I am writing to make a formal observation for the planning application An Coimisiún Pleanála - **Case reference: PAX12.324290 for Lissinagroagh Wind Farm located in located in the townlands of Boleyboy, Cashelaveela, Cherrybrook, Killea, Coolodonnell, Faughary, Lissinagroagh, Lisdarush, Lugasnaghta, Raheelin, Shasmore, Tawnyfeacle and Tullyskeherny, County Leitrim by FuturEnergy Lissinagroagh DAC.**

2. T03

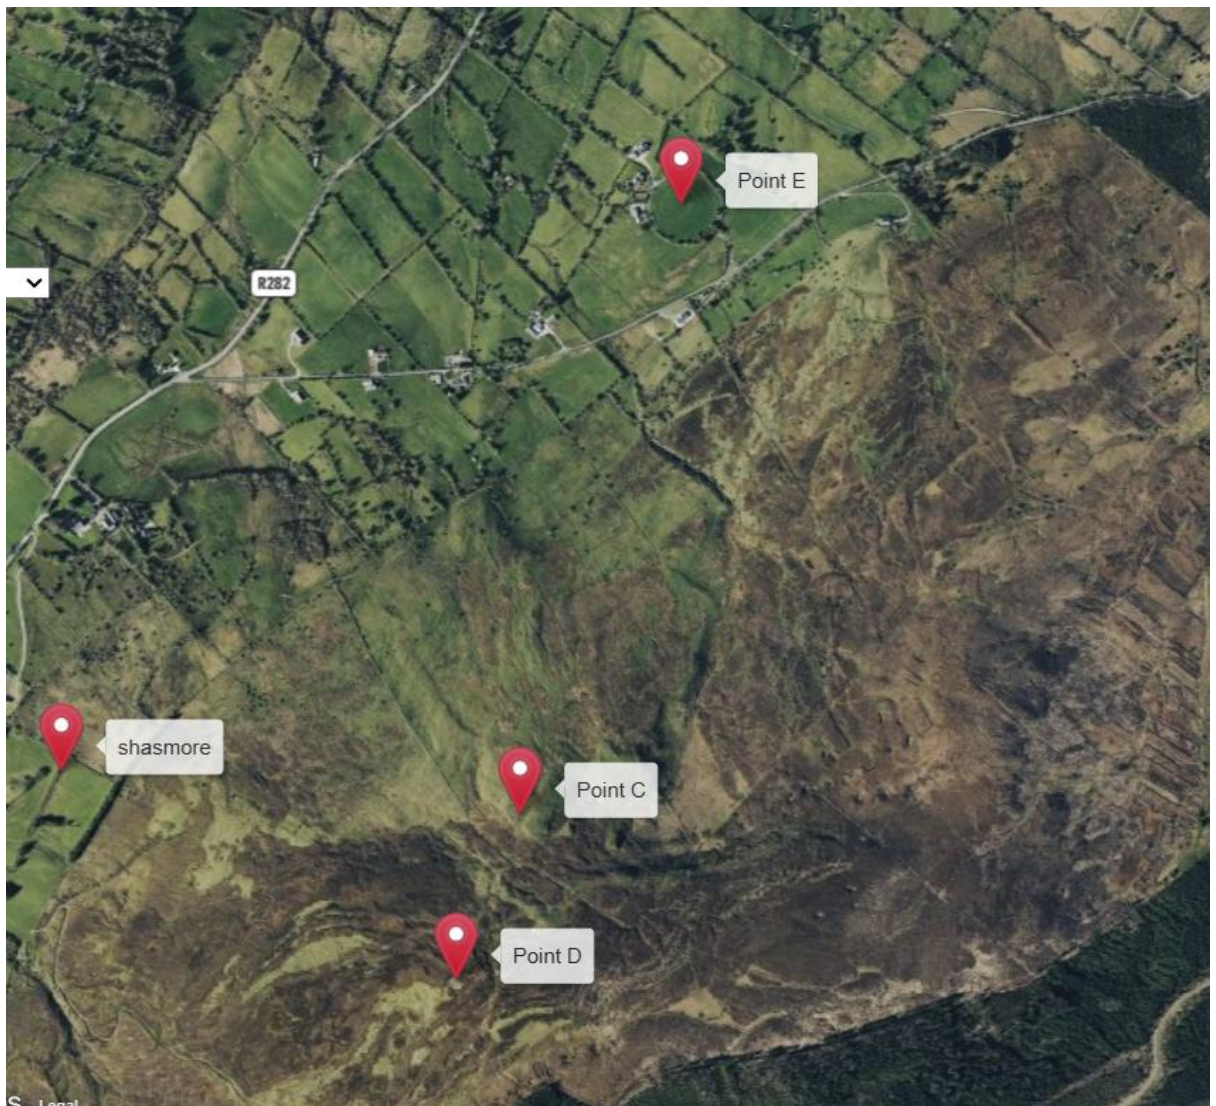
I object to the proposed 14 turbines because of their location on an upland peat bog and karst mountain. They will turn the beautiful area I know and love into an industrial landscape that completely changes the appearance of the area.

In particular, the proposed location of Turbine T03, is unsuitable for several reasons.

1.The water that comes from Saddle hill, makes its way to the Ballagh river and thereafter, into Lough Melvin from a water course that is unmarked on the

hydrology report. There is a bridge (ITM coordinates X 590569 Y 844642) which allows this water to flow under the R282 to the Ballagh river. This bridge is shown on 1935 OS 6-inch map, so it has been there for some time. This water course is not mentioned in the EIAR chapter 8 Hydrology report.

2. The risk of bog slide for the area around T03 is too large to dismiss, especially given the proximity to nearby houses.

3. As recognised in the EIAR chapter 14 ARCHAEOLOGICAL, ARCHITECTURAL AND CULTURAL HERITAGE report, the area around the proposed T03 may represent a bronze age ceremonial landscape. The report mentions a wedge tomb at AH04 and locates its nearest proposed turbine as T01. The report fails to show a dolmen (ITM coordinates X 591705 Y 844724) which is approx 280m north of the fort AH01 on the top of Saddle Hill. In the image below you can see AH01 (point D), this dolmen (point C) and larger fort AH03 (point E) all form a straight line.

To install a Turbine right beside an area of recognised archaeological significance and, as of yet unrecognised, potentially even more significance would be devastating.

4.The Visual and noise impact of T03. This turbine will be one of the closest to houses of all the proposed turbines. It will dominate the landscape of the nearest houses. The tranquillity and beauty of Shasmore will be destroyed by this Turbine T03. As the EIAR chapter 14 ARCHAEOLOGICAL, ARCHITECTURAL AND CULTURAL HERITAGE report states in 14.3.11.1 Proposed Wind Farm Site “T03 is located in a prominent position and is likely to be visible from all directions.”
